**PLANNING COMMISSION PUBLIC HEARING**

**SUBJECT:** ZMAP-2008-0017, SPEX-2008-0068, SPEX-2008-0069,  
SPEX-2008-0070, SPEX-2010-0018, SPEX- 2010-0034,  
CMPT- 2010-0014, Stonewall Secure Business Park

**RECOMMENDATION:** Staff cannot support the applications. Staff recognizes that the development could have a positive economic impact upon the County. Staff also recognizes that non-residential uses may be reasonable for all or a portion of the site, given the proximity of Luck Stone Quarry and a future power plant and water treatment plant. However, with a proposed density of 0.6 FAR, a potential building area of 4.9 million square feet, and maximum building heights of 100 feet, the scale and intensity of the proposed development is inconsistent with the rural character, lower densities, and higher open space requirements envisioned for the Lower Sycolin subarea of the Transition Policy Area and incompatible with the residential uses to the west. Further, the application has outstanding open space, transportation, and environmental issues.

**Graphic 2. Building Heights.  
 Substation and Potential Water Treatment/  
 Water Tank Locations.**

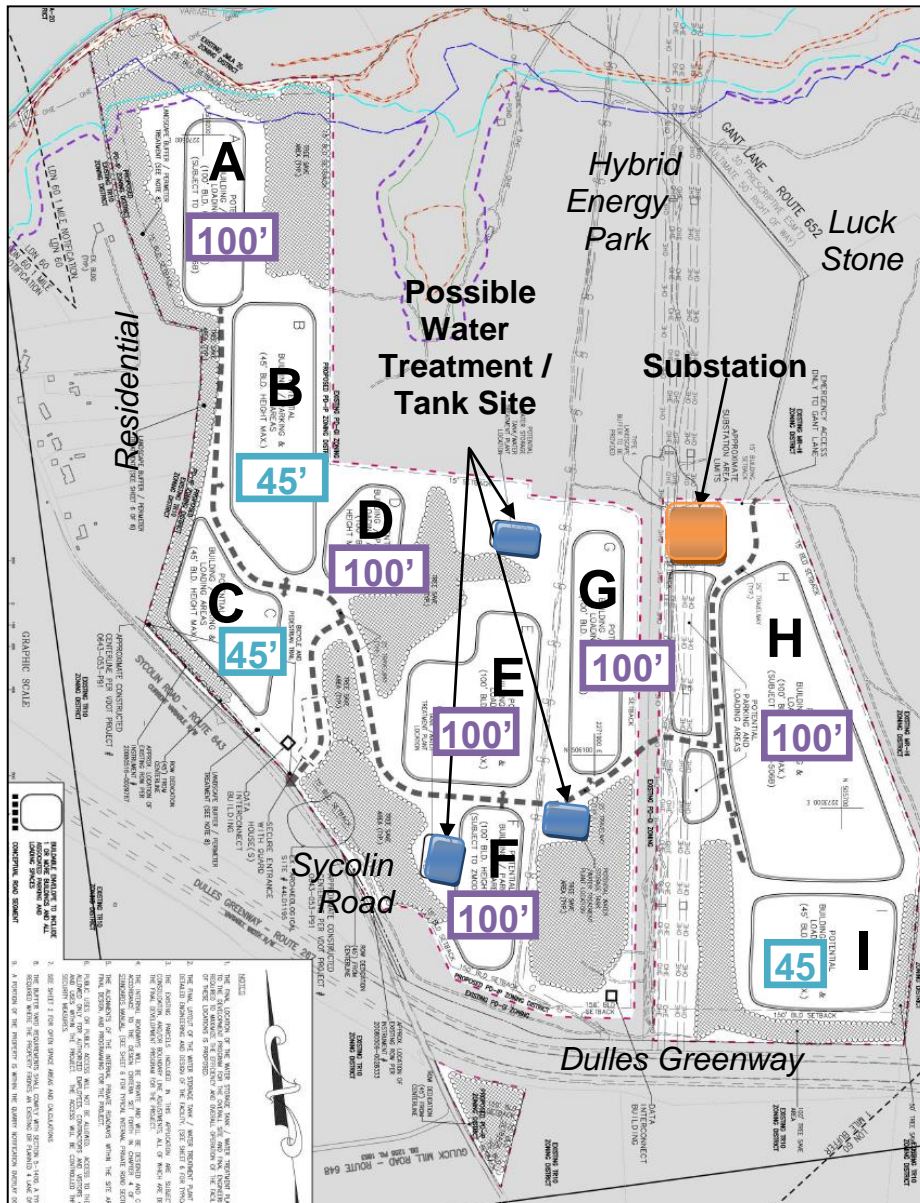
1. **Building Height** – The proposed 100-foot tall building heights are a significant departure from the 40-foot maximum that the Revised General Plan envisions for the Transition Policy Area. The Policy Area's design guidelines for non-residential developments along major collector roads, such as Sycolin Road, state that non-residential uses will develop at a scale that would allow them to blend effectively into a rural landscape, that building scale should not dominate over the natural landscape, that building heights should relate to the surrounding landscape and the heights of adjacent structures.

The Applicant has agreed to limit building heights adjacent to the residential properties to the west and the Dulles Greenway to 45 feet (Land bays B, C, and I). Staff has also asked the Applicant to consider other possible **solutions, including proffering to construct some floors underground and reducing the proposed maximum building height within the remaining land bays.**

**Graphic 3. Staff Recommended Mitigation of Phase 3 Transportation Impacts**

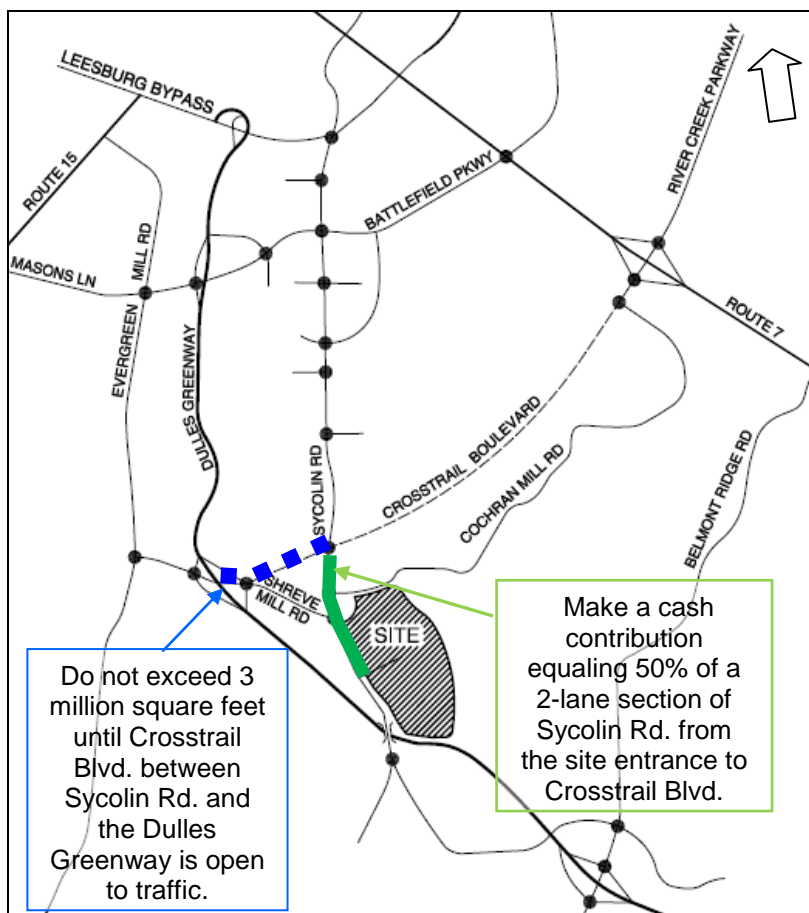
- 1. Mitigation of Phase 3 Transportation Impacts** – The application does not currently mitigate its Phase 3 transportation impacts to the north of the site. At full build-out, the project would add 10,995 average daily trips to the road network, which is currently operating at an unacceptable Level of Service. The Applicant's Traffic Study indicates that the two following improvements need to be in place in order to accommodate the background traffic and Phase 3 of the proposed development (exceeding 3 million square feet).

The issue is that the proffered cash contribution is less than the anticipated contribution of \$0.89 per square foot of development (\$4.36 million). At full build out, 50 percent of the AM and PM peak hour traffic on Sycolin Road north of the site will be site-generated. The section of Sycolin Road that would reasonably be used to access the site from the north is between Sycolin Road and Crosstrail Boulevard. Therefore, Staff finds that the fair share contribution is 50 percent of the cost to design and construct two lanes of Sycolin Road between Crosstrail Boulevard and the site entrance (50% x \$ 8,735,400). Refer to Exhibit A for calculations prepared by the County Office of Capital Construction based on current projects and budgets.

The Applicant also proffers to limit development to 3.5 million gross square feet until the segment of Crosstrail Boulevard between Sycolin Road and the Dulles Greenway is in place (by others). For consistency with the Traffic Study, Staff recommends that the proffers limit development to 3 million square feet until that section of Crosstrail Boulevard is in place.

**Graphic 4. Cochran Mill Road Right-of-Way Dedication**

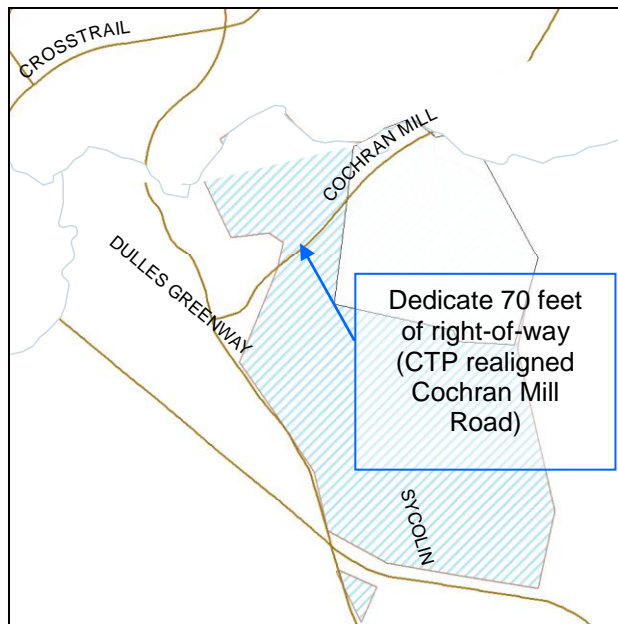
2. **Cochran Mill Road Right-of-Way Dedication**

– The Concept Development Plan does not show a 70-foot wide right-of-way dedication for the planned realignment of Cochran Mill Road. The Applicant wishes to move forward to the Board of Supervisors without dedicating or reserving right-of-way for Cochran Mill Road, because the Applicant does not think it will be needed; the Applicant believes that Crosstrail Boulevard will serve the needs of the planned realigned Cochran Mill Road. At a minimum, Staff recommends that the Applicant proffer to reserve right-of-way to be dedicated at the request of the County or VDOT.
